SUBMITTAL OF DANGEROUS WASTE PERMIT PACKAGE PTF-009, REVISION 2, FOR THE PRETREATMENT FACILITY

Permit Package PTF-009, Revision 2, Supplemental
Permit Package for FRP-VSL-00002A, FRP-VSL-00002B,
FRP-VSL-00002C, and FRP-VSL-00002D Vessel Alterations

Supplemental Permit Package PTF-009, Rev. 2 Description
Vessel Alterations to FRP-VSL-00002A/B/C/D

SECTIONAL ELEVATION

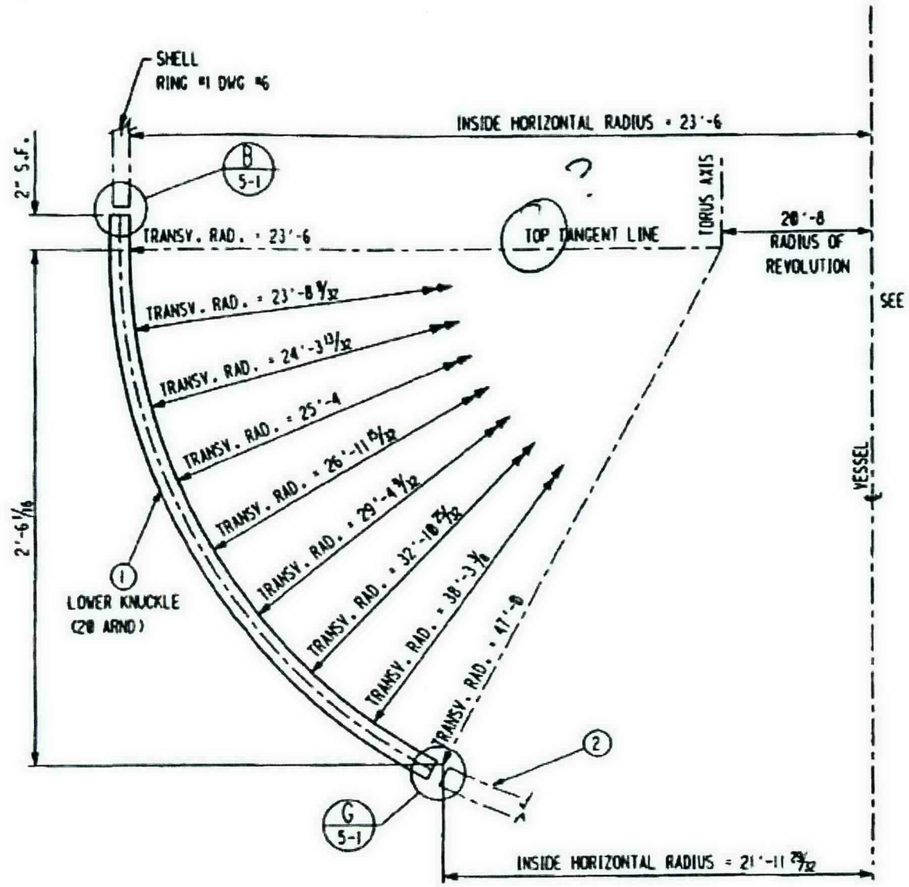
ADD KNUCKLE STIFFENER DETAILS BY RPP-WTP ON HOLD

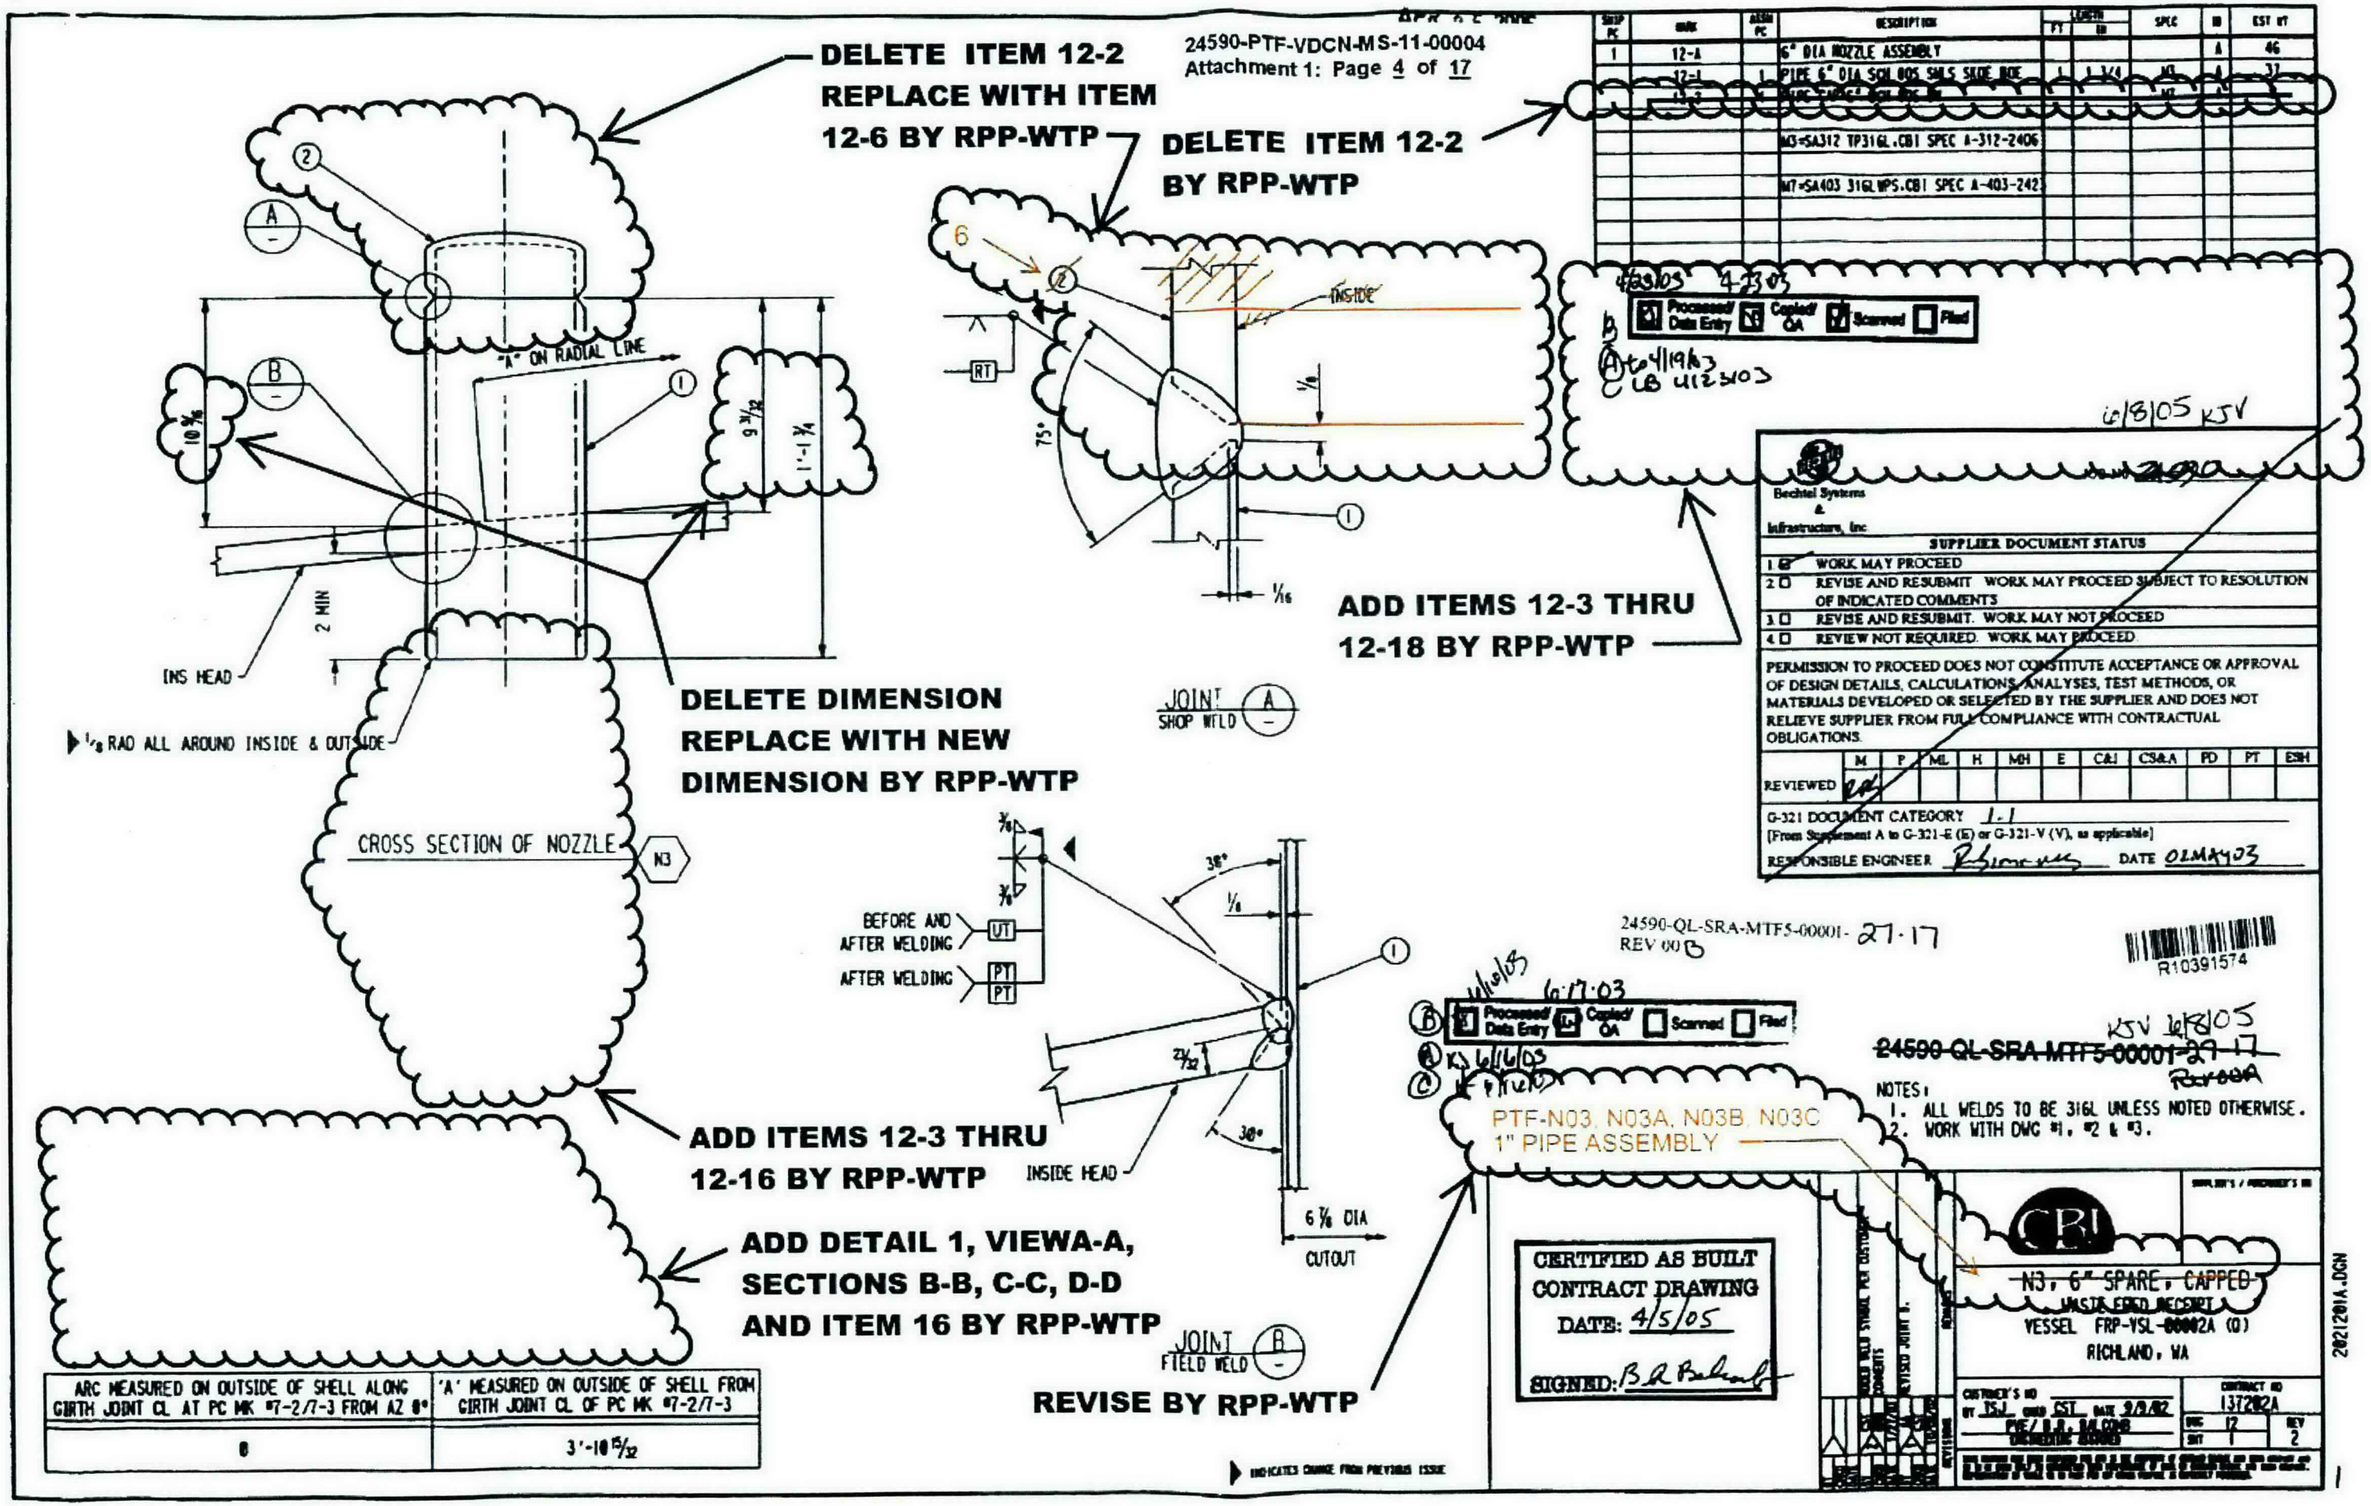
REVISE BY RPP-WTP

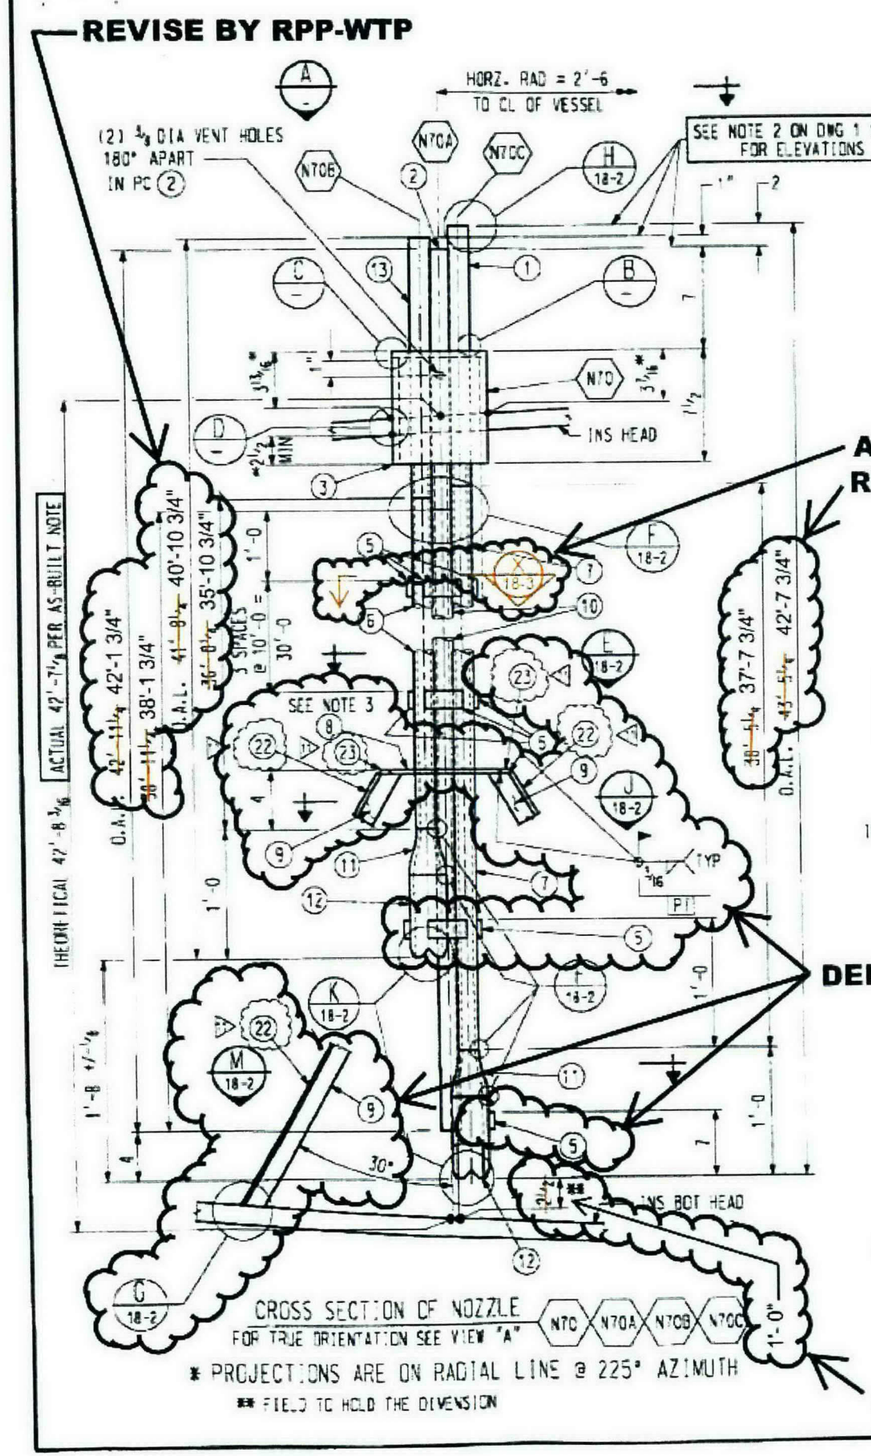
ADD BY RPP-WTP

REVISE BY RPP-WTP

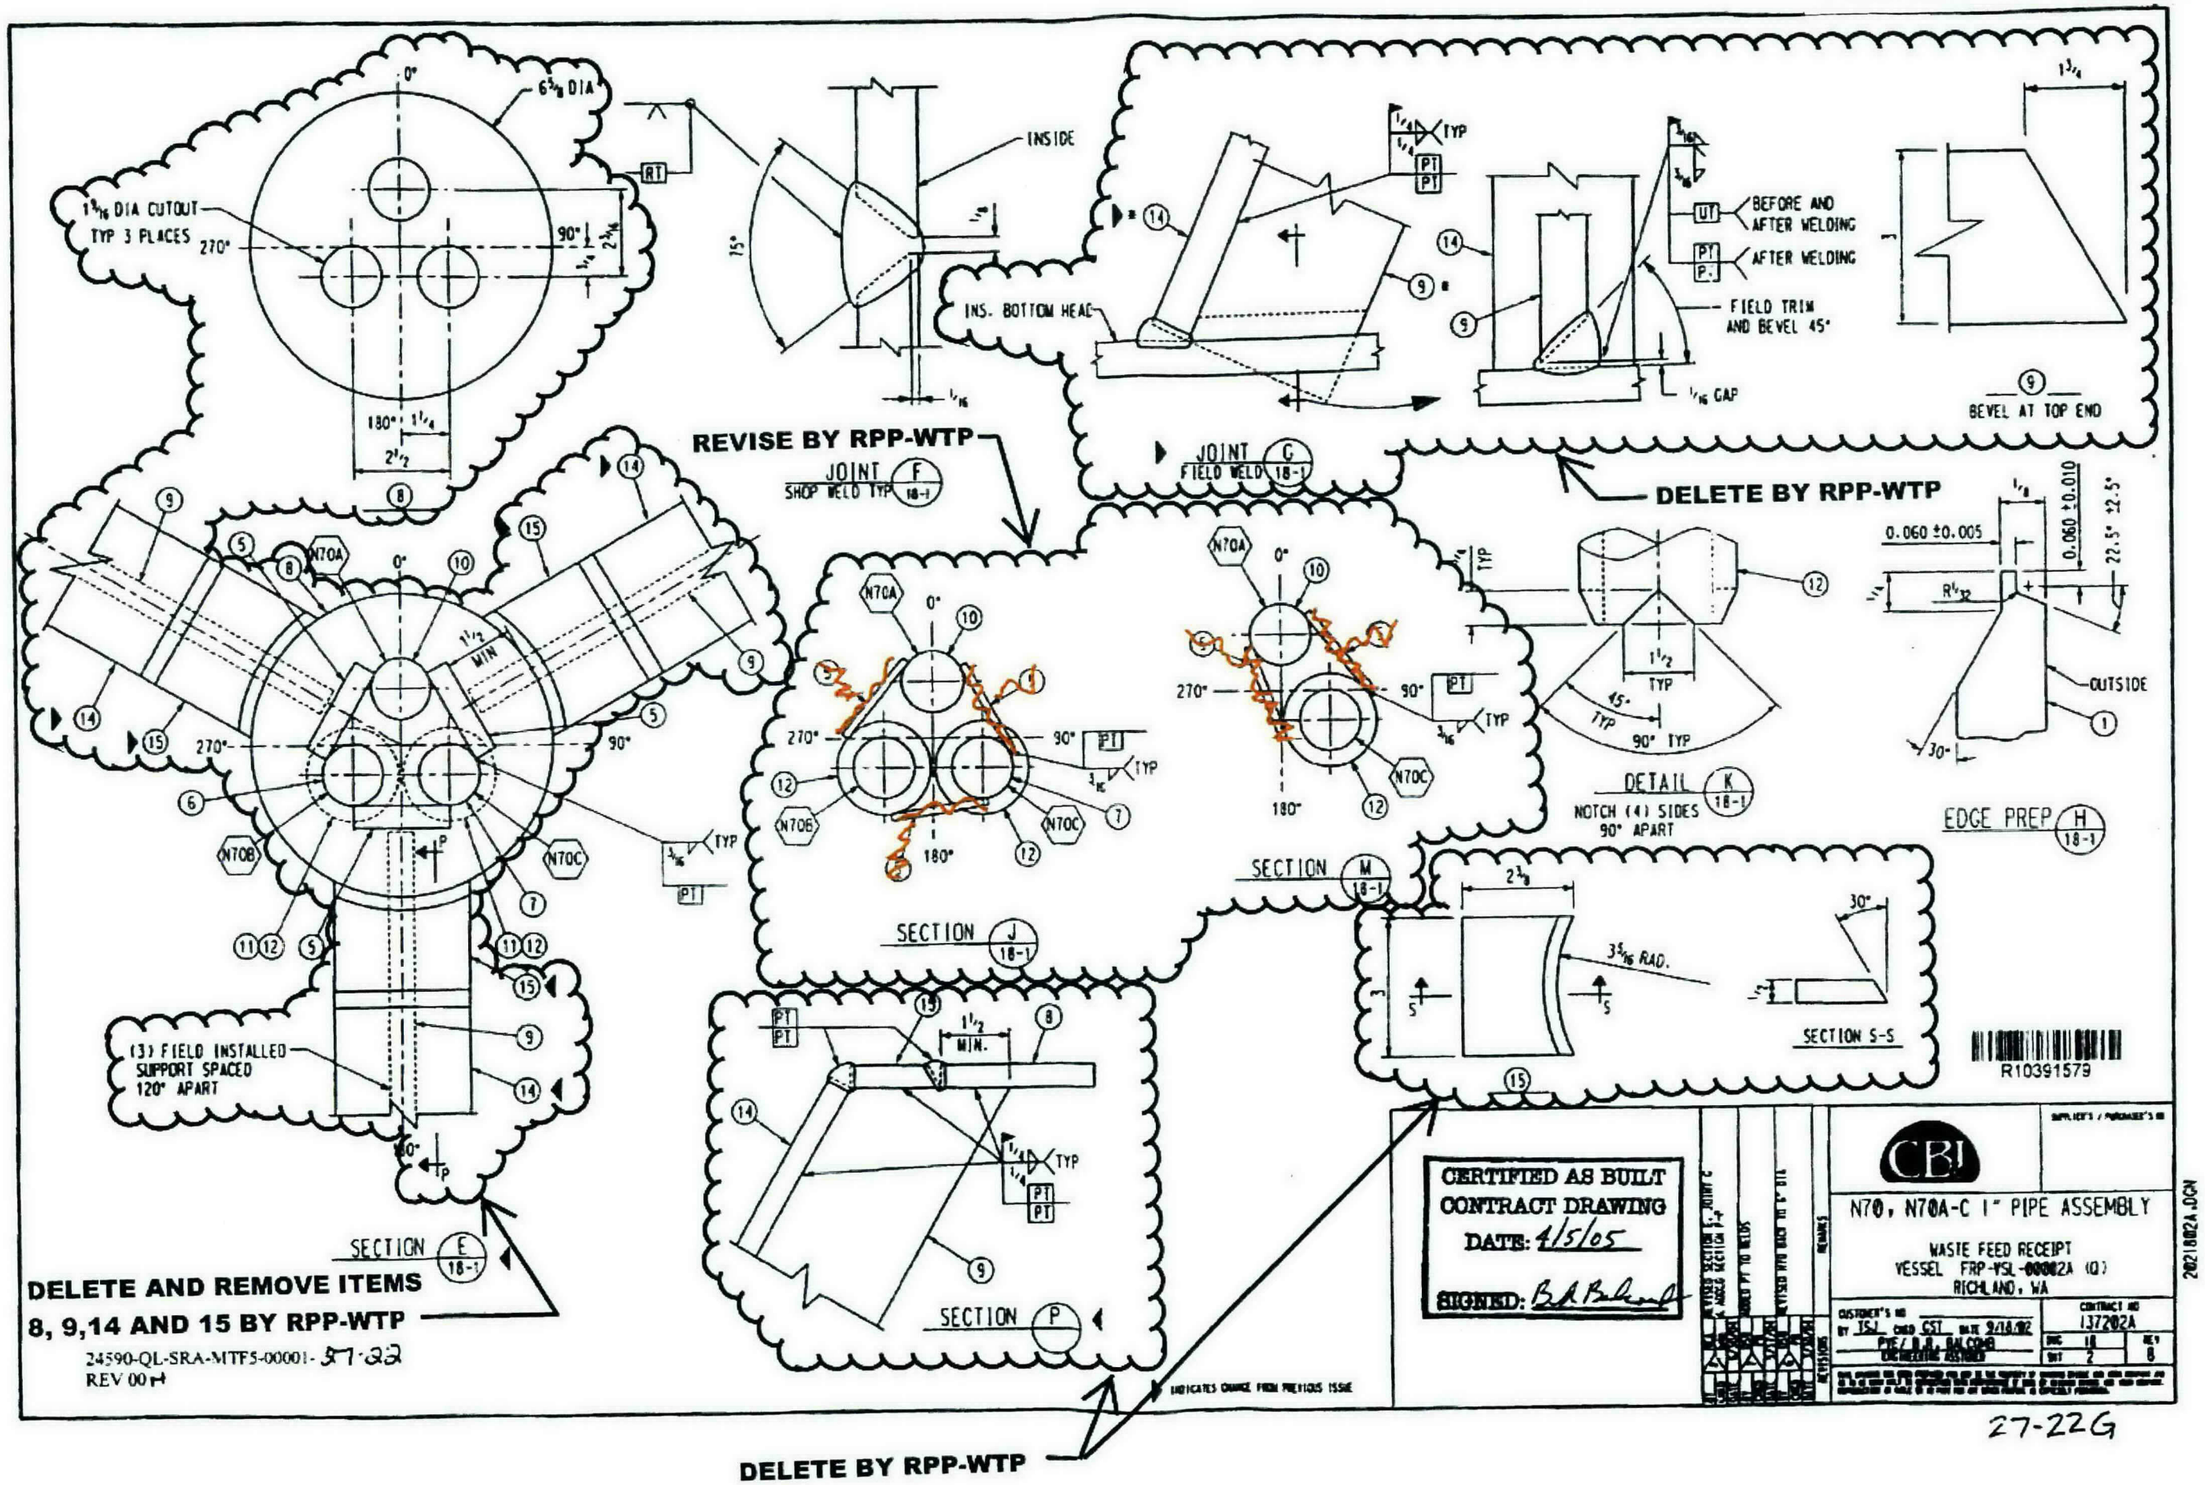
6 3/8 DIA
1 9/16 DIA CUTOUT TYP 3 PLACES
INSIDE
INS. BOTTOM HEAD
REVISE BY RPP-WTP
JOINT F SHOP WELD TYP 18-1
JOINT G FIELD WELD 18-1
DELETE BY RPP-WTP
BEFORE AND AFTER WELDING
AFTER WELDING
FIELD TRIM AND BEVEL 45°
1/16 GAP
BEVEL AT TOP END
DETAIL K 18-1
NOTCH (4) SIDES 90° APART
EDGE PREP H 18-1
OUTSIDE
SECTION J 18-1
SECTION M 18-1
SECTION S-S
3 5/16 RAD.
SECTION E 18-1
(3) FIELD INSTALLED SUPPORT SPACED 120° APART
SECTION P
DELETE AND REMOVE ITEMS 8, 9,14 AND 15 BY RPP-WTP
24590-QL-SRA-MTF5-00001-
REV 00
CERTIFIED AS BUILT CONTRACT DRAWING
DATE: 4/5/05
SIGNED:
CBI
N70, N70A-C 1" PIPE ASSEMBLY
WASTE FEED RECEIPT
VESSEL FRP-VSL-00002A (Q)
RICHLAND, WA
137202A
R10391579
DELETE BY RPP-WTP
